UNITED STATES PATENT AND TRADEMARK OFFICE

APPLICATION NO.	FILING DATE	FIRST NAMED INVENTOR	ATTORNEY DOCKET NO.	CONFIRMATION NO.
10/820,737	04/09/2004	Jong-eun Chae	1572.1290	9002

Office Action Summary	Application No. 10/820,737	Applicant(s) CHAE ET AL.	
	Examiner Michael J. Early	Art Unit 3744

FIG. 4

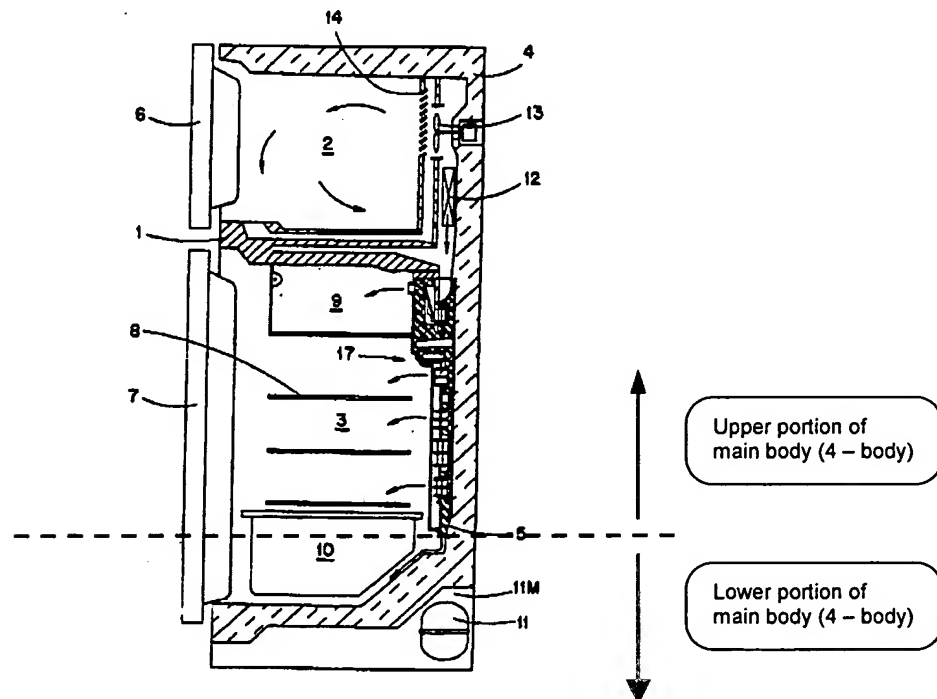
- a main body (4 – body) formed with a storing compartment (3 – refrigerator compartment) (as seen in Figure 4);
- a first cool air duct (middle portion of 25 – cool-air duct) provided in a rear of the main body (see col. 5, lines 19-25; Figure 6);

- a lamp unit mounted in an upper part of the main body (as seen in the illustration of Figure 4 below) and comprising a lamp (30 – indoor lamp) and a lamp case (31 – lamp cover) (as seen in Figures 4, 6);

- a second cool air duct (lower portion of cool-air duct [25]; col. 5, lines 19-25) that is formed in an upper part of the lamp case to communicate with the first cool air duct (as seen in Figure 6) and allows cool air flowing through the first cool air duct to flow out toward a front of the storing compartment of the main body (in an indirect manner);

- the second cool air duct is formed in the lamp case as one body (as seen in Figure 6);
- the second cool air duct is detachably formed in the lamp case (as seen in Figure 6);

- the second cool air comprises an upper case (24 – front cover) and a lower case (34 – seal plate) engaged to each other (depending on your perspective);
- the lower case comprises an insulator (see col. 5, lines 33-37);
- an air chamber (15 – cool-air passage) located at a front of the lamp unit (depending on your perspective) and coupled to the second cool air duct (as seen in Figures 6, 9A);
- wherein the cool air from the second cool air duct is discharged through the air chamber to the front of the storage compartment (in an indirect manner) and the air chamber includes a discharge grate (16A, 16B, 16C – cool-air discharge openings) to disperse the cool air evenly across the front of the storage compartment (in an indirect manner).

- a main body (4 – body) housing a plurality of refrigeration components (11 – compressor, 11M – machine compartment, condenser and pressure reducing device, 12 – evaporator; col. 4, lines 64-67; col. 5, lines 1-16) and a climate controlled storage compartment (9 – third compartment) that includes an opening selectively covered by a door (7 – refrigerating compartment door) (as seen in Figures 4, 5);

- a lamp unit (see col. 5, lines 41-44) mounted above the storage compartment (as seen in Figures 5, 6);
- a cool air duct (25 – cool-air duct) contiguous with the lamp unit (as seen in Figure 6) wherein the cool air flowing from the plurality of refrigeration components is discharged to a front of the storage compartment by the cool air duct (in an indirect manner);
